SUBDIVISION REVIEW SHEET

CASE NO.: C8J-2019-0090.1A

SUBDIVISION NAME: Stoney Ridge Highlands, Phase 1

**CITY OF AUSTIN – TRAVIS COUNTY – SINGLE SUBDIVISION OFFICE
SUBDIVISION APPLICATION – MASTER COMMENT REPORT**

SHEET NO. 3 OF 11

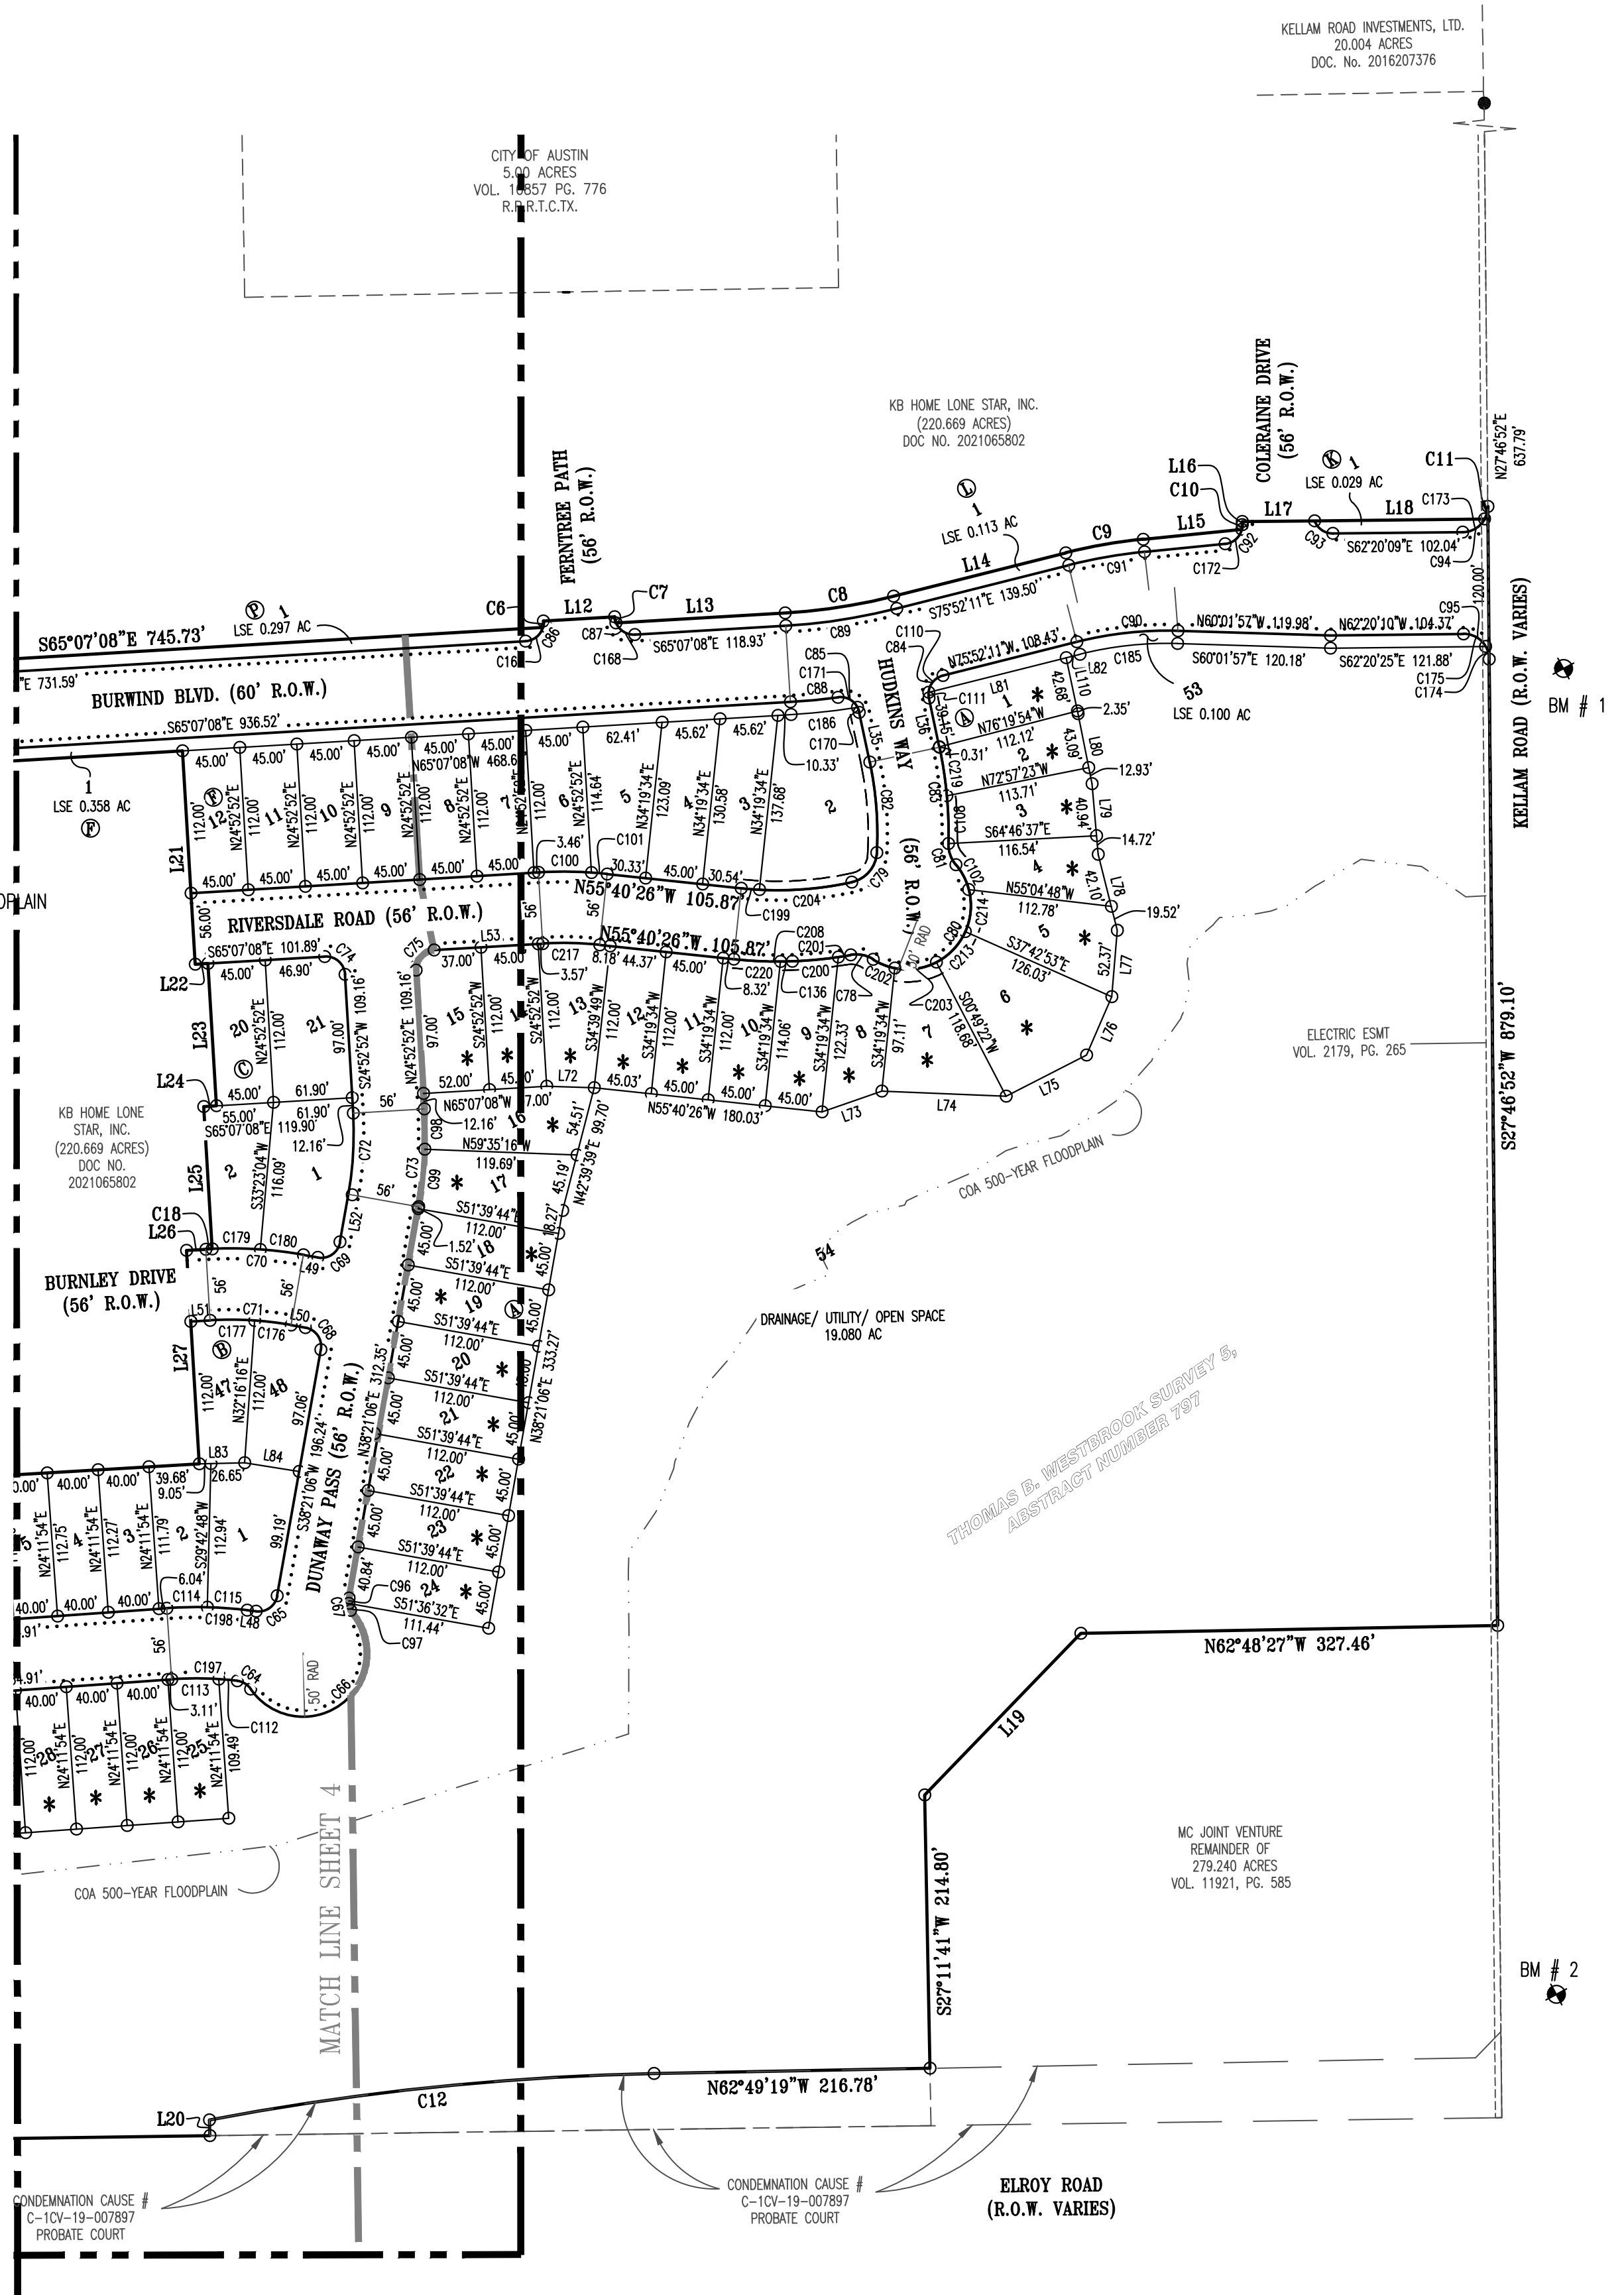
SR 2. The final plat does not match the approved preliminary plan, lots on Sheet 3 of the plat are not similar in the preliminary plan. The case will require a deviation or revision to the preliminary plan to approve the plat, refer to [L.D.C. 25-4-61](#) to verify the type of revision that can be used to update the preliminary plan.

If a deviation can be filed, forward a redlined copy of the preliminary plan annotating the changes to the plan and a memo requesting the deviation with a brief description of the changes to the preliminary plan. This application can be filed with the final plat.

If a minor revision to the preliminary plan is needed, this type of change to the plan requires a formal application approved administratively. 25-1-83 or 30-1-113

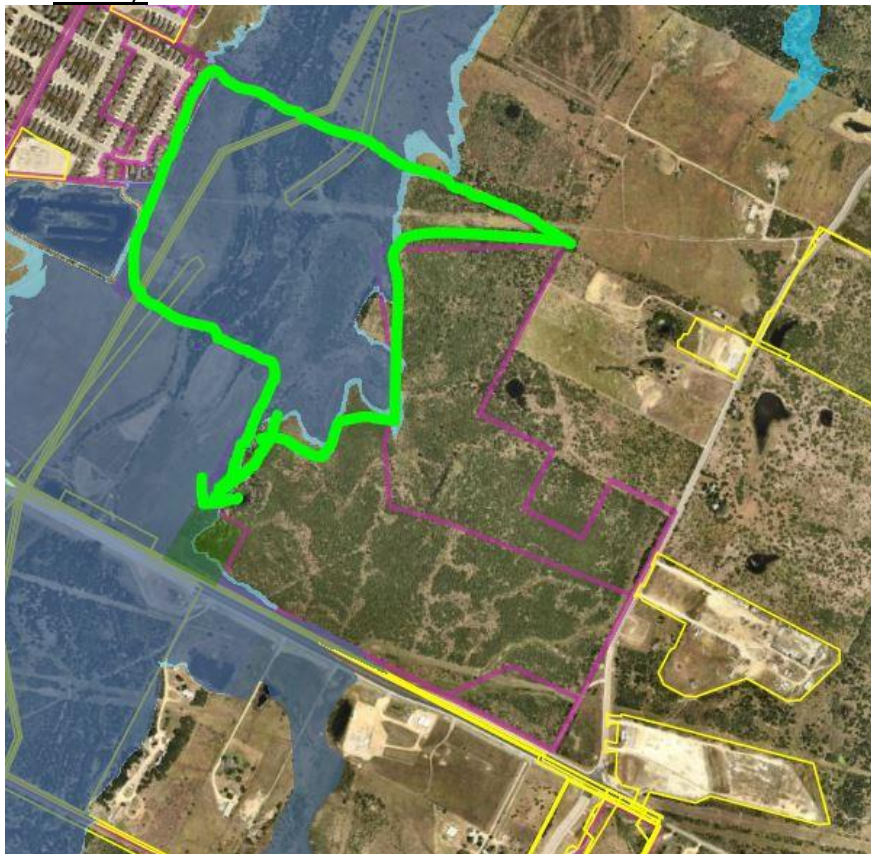
PR3. Title 25 is applicable in terms of parkland. Parkland dedication is required per Chapter 25-1, Article 14 (Parkland Dedication) of the City Code prior to approval of this subdivision. The parkland may be provided on-site as a wide connection from Elroy Park to the northern portion of the site, along Dry Creek East. Indicate where the applicant intends to dedicate parkland or a park easement. Contact the PARD reviewer for further discussion. (see conceptual sketch below):
